APPLICATION NO.	ISSUE DATE	PATENT NO.	ATTORNEY DOCKET NO.	CONFIRMATION NO.
13/480,704	09/13/2016	9441453	SAFO/0012USP1	9598

ISSUE NOTIFICATION

SAFETY VALVE CONTROL SYSTEM AND METHOD OF USE

KLX Energy Services LLC v. Safoco, Inc.
Safoco – Exhibit No. 2004
IPR2024-00198
Page 105

FIG. 12

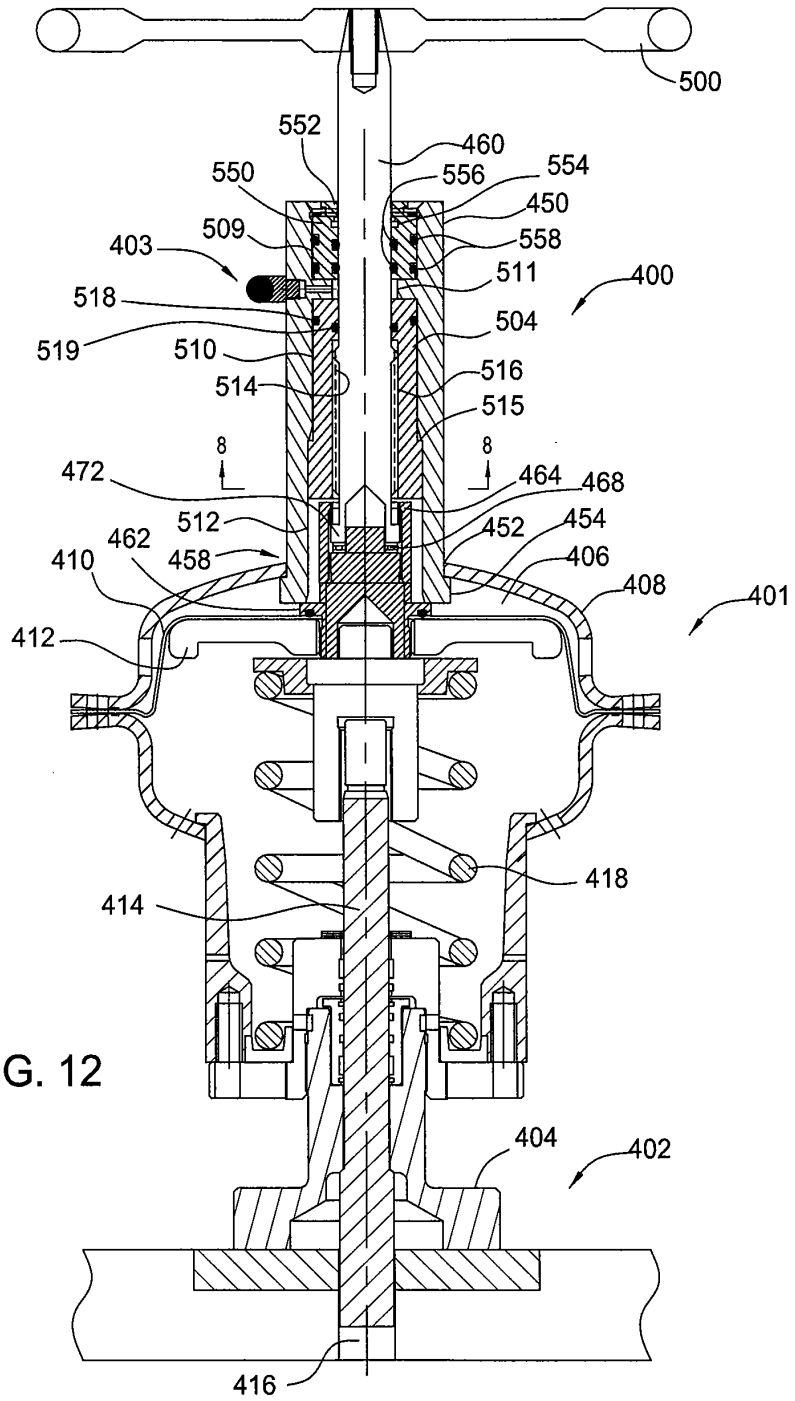
The drawings stand objected to because they fail to disclose the features of claims 7, 16, and 21. Applicants submit that Figure 12, as described in paragraph [0066] of the specification, illustrates the gate valve 402 in a (spring biased) fail-safe open position. Applicants respectfully request withdrawal of the objection.

Claims 7, 16, and 21 stand rejected under 35 U.S.C. § 112. Applicants submit that paragraph [0066] of the specification describes, and Figure 12 illustrates, the gate valve 402 in a (spring biased) fail-safe open position. Applicants respectfully request withdrawal of the rejection.
